November 05, 2018

Flood Damage Reduction Segment / System Inspection Report

Name of Segment / System: North Nashua River

Inspection Start Date: 06/14/2018

Photo 24. Circle Street: Failing 3-story building wall overhanging upstream, left bank.

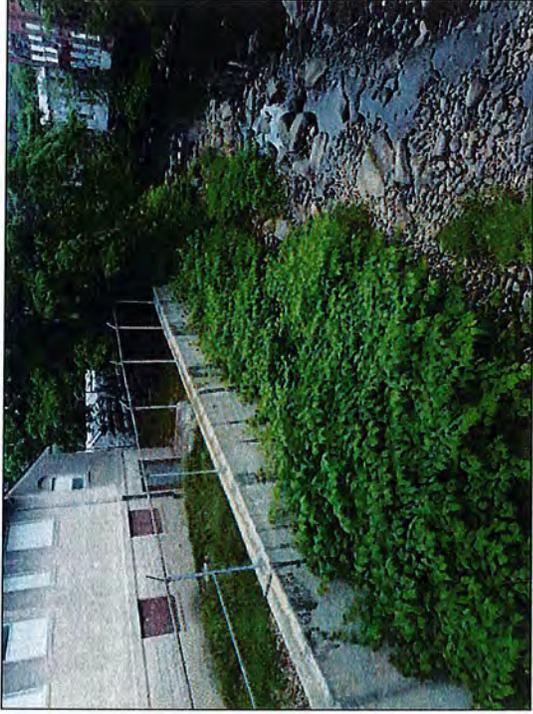
Rated Item	Rating	Rating Guidelines	Location/Remarks/Recommendations
1. Vegetation and Obstructions	A	No obstructions, vegetation, debris, or sediment accumulation within the channel. Concrete channel joints and weep holes are free of grass and weeds.	Significant vegetation consisting of large brush and trees greater than 2-inch diameter along the channel slopes of the entire project, with greater than 6-inch diameter present at each inspected segment. Vegetation needs to be cleared to prevent any reduction in flow during a flood event in accordance with Engineering Technical Letter 1110-2-583. Refer to photos 1-56. (U) Ornamental trees planted adjacent to the floodwall within the shopping complex by the Water Street bridge. Refer to photo 10. Remove trees. (M) A three story brick building wall on the Circle Street, upstream left bank is failing, with debris falling into the channel. The wall is bowed vertically, and may be also bowed toward the channel. If the wall collapses, it could block the channel. Work with the building owner to stabilize the wall or monitor the building and remove debris from the channel. Refer to photo 24. (U)

Photo 29: Circle Street: 6 inch diameter tree displacing blocks out of stone wall, downstream, left bank.

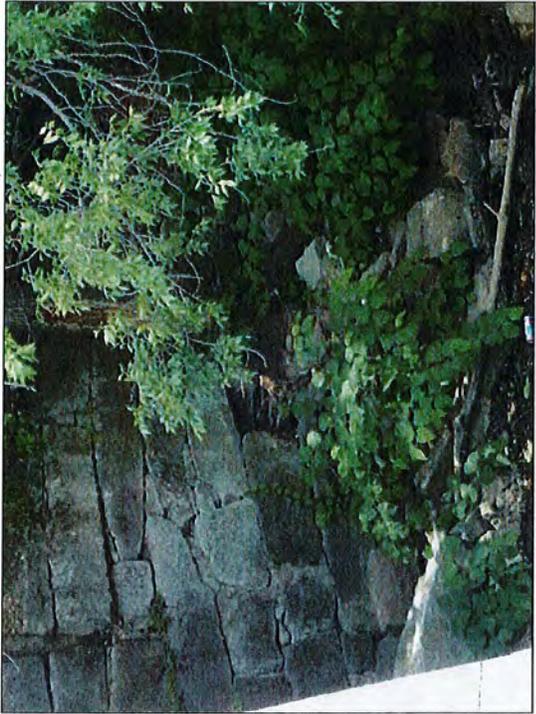
4. Erosion	U	No head cutting or horizontal deviation observed.	Channel embankments could not be inspected due to high vegetation. Trees on the downstream left bank of the Circle Street bridge are displacing stone blocks out of the retaining
	M	Head cutting and horizontal deviation evident, but is less than 1 foot from the designed grade or cross section.
